**OPEN TENDER ENQUIRY FOR ELEVATORS FOR 1X 800 MW GSECL WANAKBORI
STPP, UNIT No. 8**

Ref No. : PE/PG/WAN/E-5127/2015

CORRIGENDUM/ ADDENDUM- 9

AMENDMENT-02 TO TECHNICAL SPECIFICATION FOR ELEVATOR
(SPEC NO. PE-TS-408-502-A001)

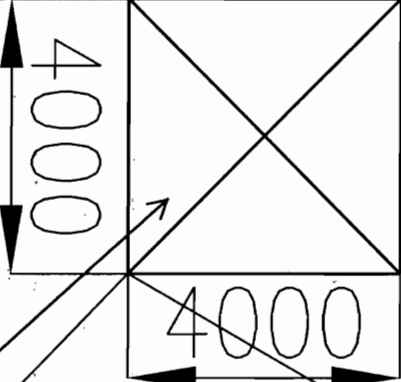
Sl. no	Building	No. of elevators	Capacity	No. of landings	Total rise	Type	Speed
3	Mill Area	1 No.	2000 Kg	<i>Ground + Eight (8). Main landings at 0.0 m, 4.11 m, 22.75 m, 62.88 m & 73.9 m Last landing & Dummy landing at 12.0 m, 32.7 m, 44.10 m & 56.30 m</i>	73.9 M	Conventional Type (Goods cum passenger elevator)	0.5 M/s

Details of Elevator shaft well dimension as per layout is 4000 mm x 4000 mm is tabulated below. For location a sketch is attached with this annexure.
